GENOA CHARTER TOWNSHIP  
ZONING BOARD OF APPEALS  
JANUARY 15, 2013  
6:30 P.M.

**Charter Township of Genoa**  
**ZONING BOARD OF APPEALS**  
**JANUARY 15, 2013**  
**CASE #12-27**

<b>Attention:</b>	Kelly Van Marter, AICP Assistant Township Manager and Planning Director
<b>Subject:</b>	Champion Buick/GMC building expansion/alteration – Sketch Plan Review #1
<b>Location:</b>	7885 W. Grand River Avenue – north side of Grand River Avenue, just west of Hacker Road
<b>Zoning:</b>	GCD General Commercial District

**Concept 1**

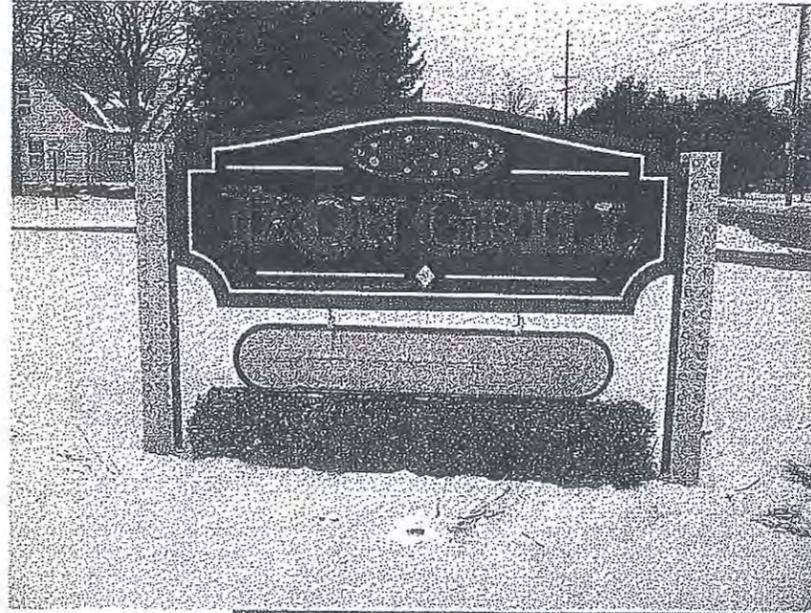
Note that I made the borders around the cabinets grey so they would be easier to see for purposes of this concept, actual cabinets will be black with black trim. Also, if you would like and the township will allow, we can extend the carriage lamps up so they extend above the top sign cabinet. We could do that by just using the same cap should work. I was also thinking, with the message center being white, we could make the background for the Burroughs cabinet black and use V at no greater cost. Otherwise it may be too much white. That detail shouldn't matter for your variance, but it is something we should consider when we move forward.

The total height of the message center and the Burroughs sign cabinet is 72". The bottom of the message center will be about 5-6" off the ground and the tips of the carriage lamps will be about 3-4" above the top sign cabinet. The total height of the existing sign, from the ground to the top of the carriage lights is approximately 80".

Add 3' x 15' readerboard  
= 45 sq. ft.

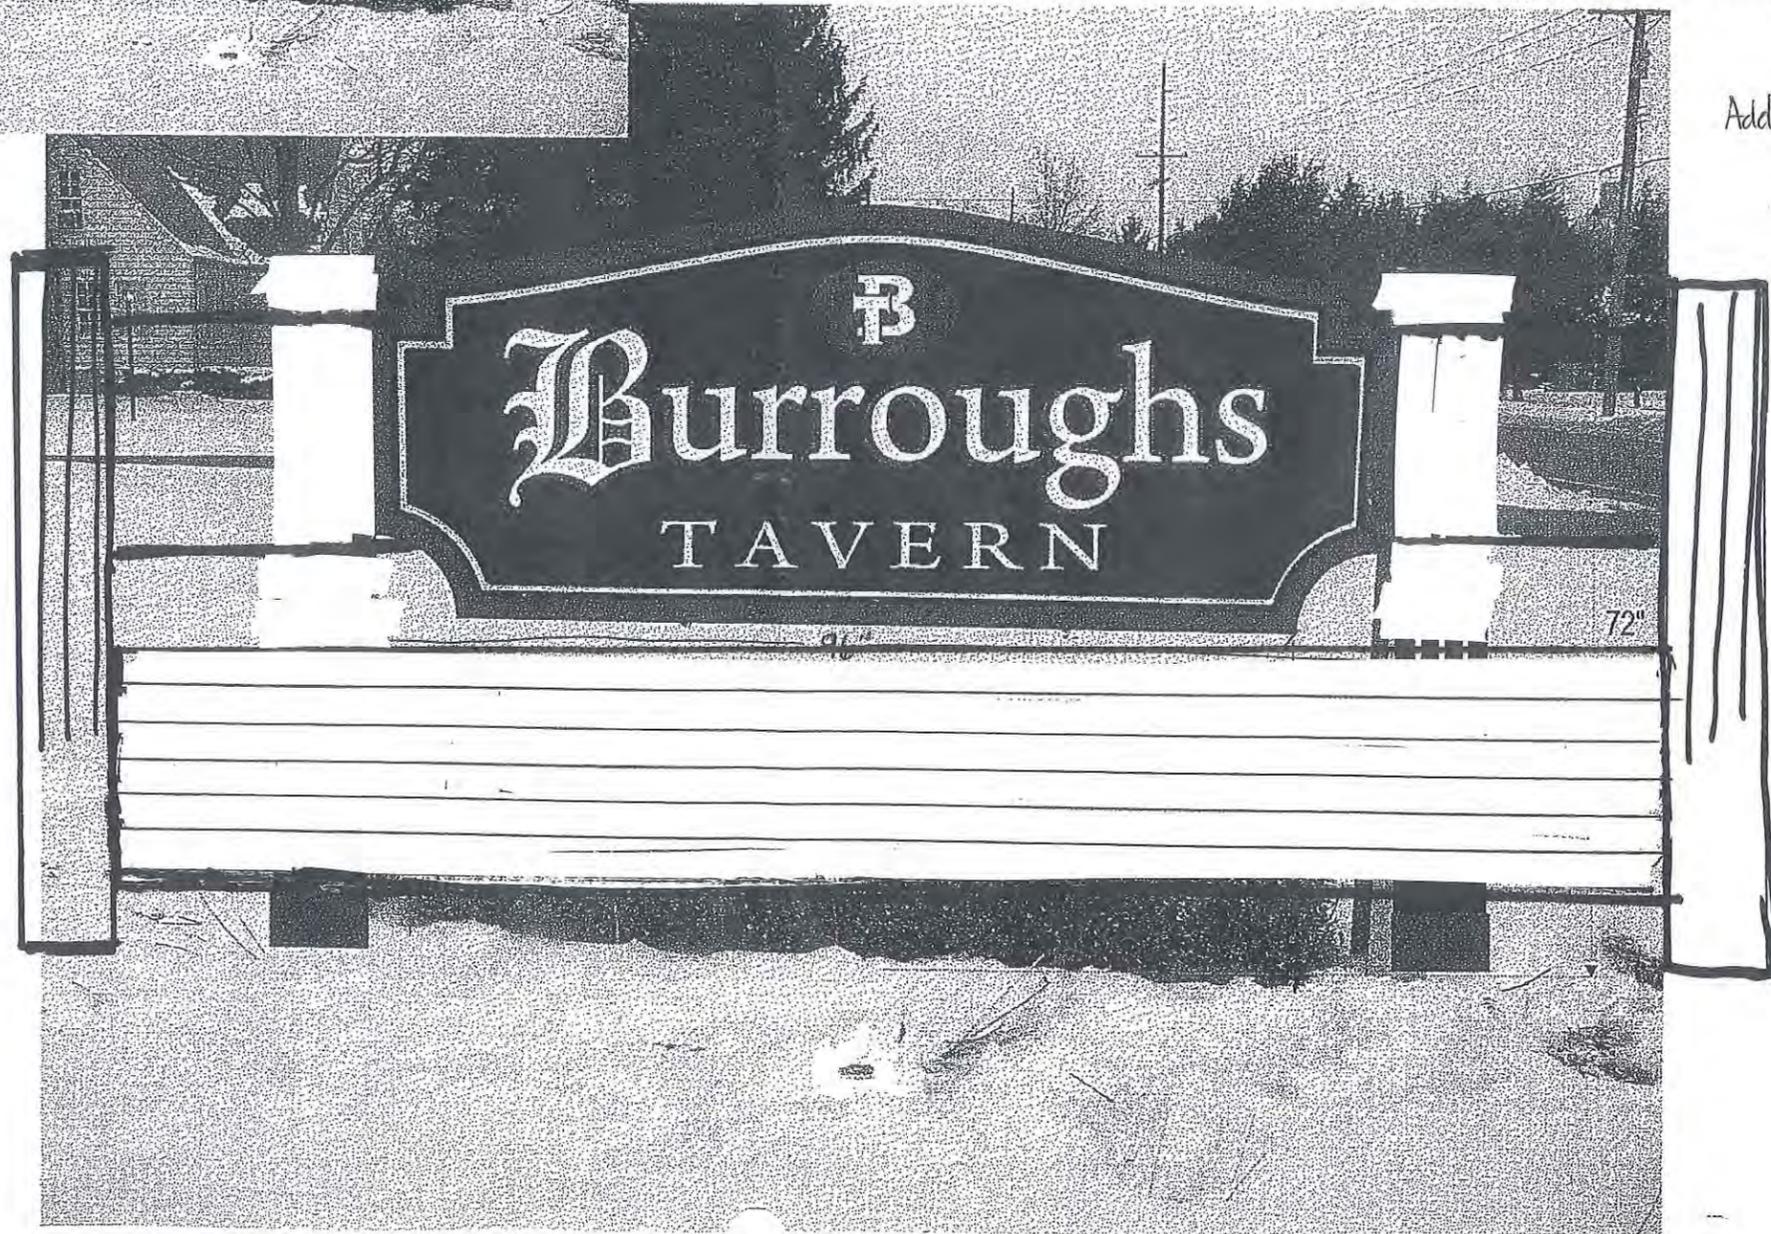
- 24 sq. ft. existing -  $\frac{1}{3}$  of what is allowed.  
- Can add an additional 48 sq. ft.

FRONT ELEVATION

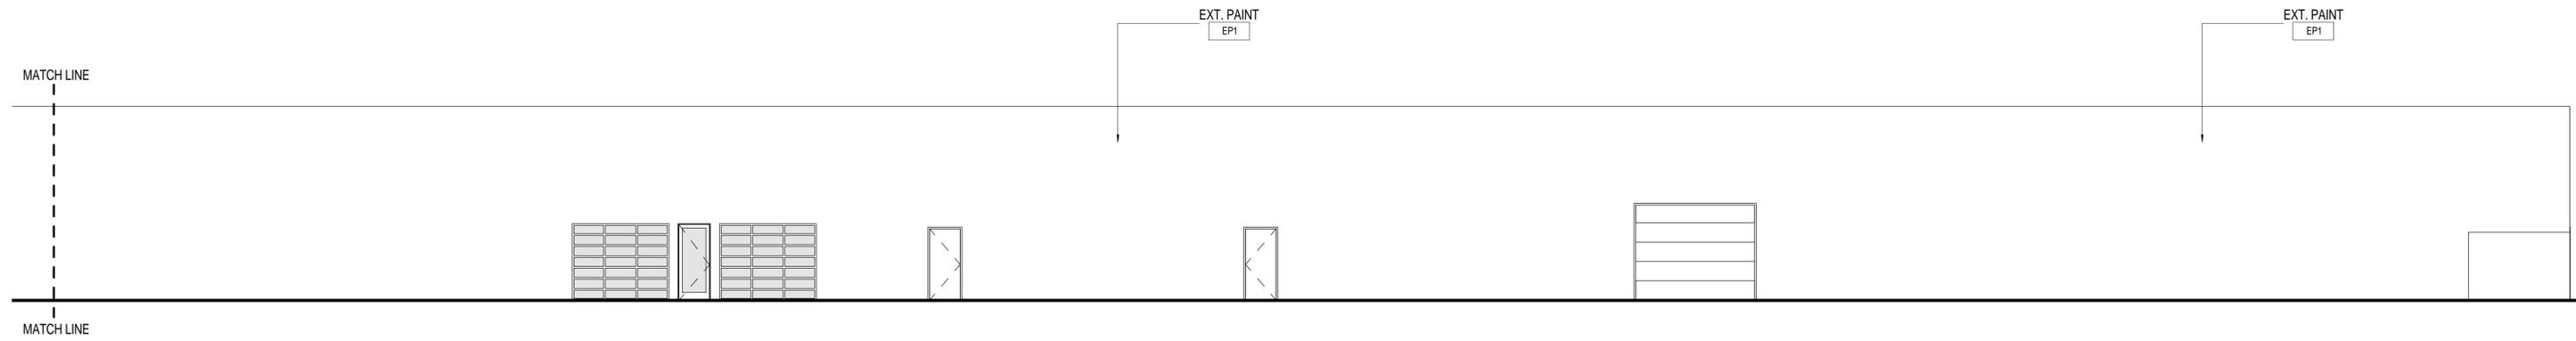
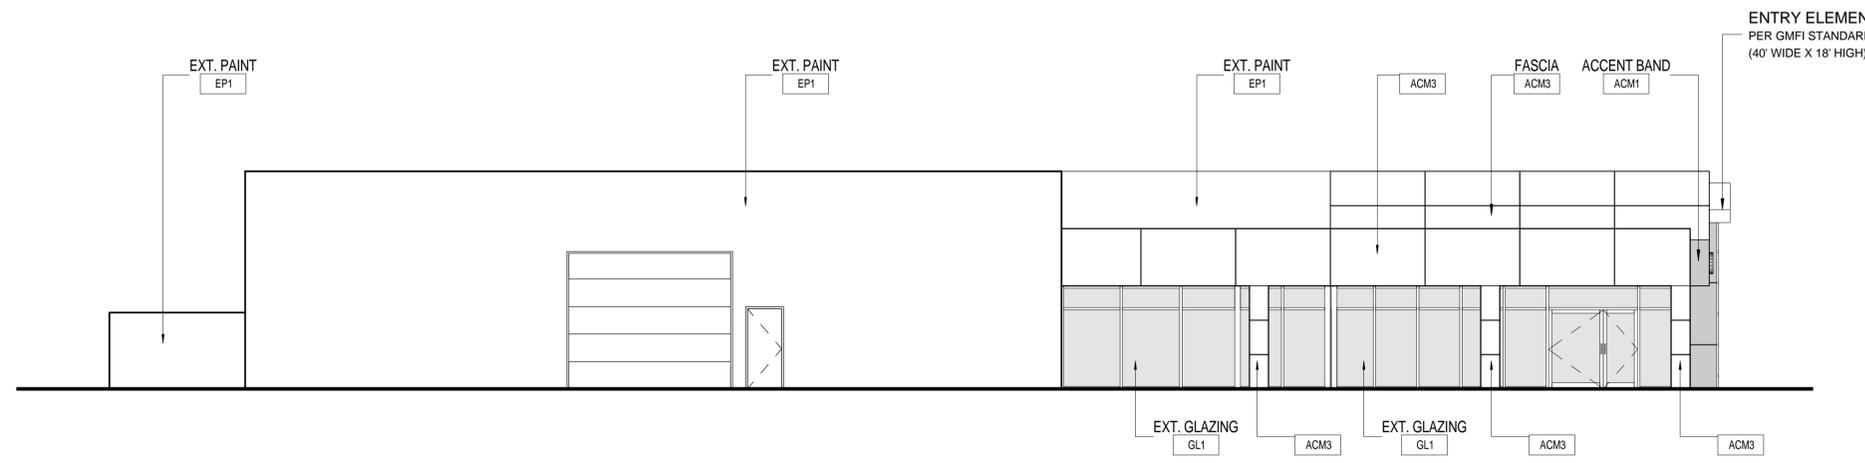
- 2. Building Materials and Design.** The proposed elevations, including colors and materials, are subject to review and approval by the Planning Commission. The materials proposed are unclear based on the information provided to our office. The applicant should be prepared to present this information to the Planning Commission for their consideration.

7. **Signs.** The site plan identifies an existing (nonconforming) pole sign fronting Grand River Avenue, while the elevation drawings show several wall signs, including those for "Champion," "Buick," "GMC," and "Certified Service." The "Champion" and "Certified Service" appear to exist, while the others are proposed as part of the new entryway. Given the site is a through-lot, Table 16.I permits only two wall signs. As such, the applicant may wish to add this to their pending variance request.
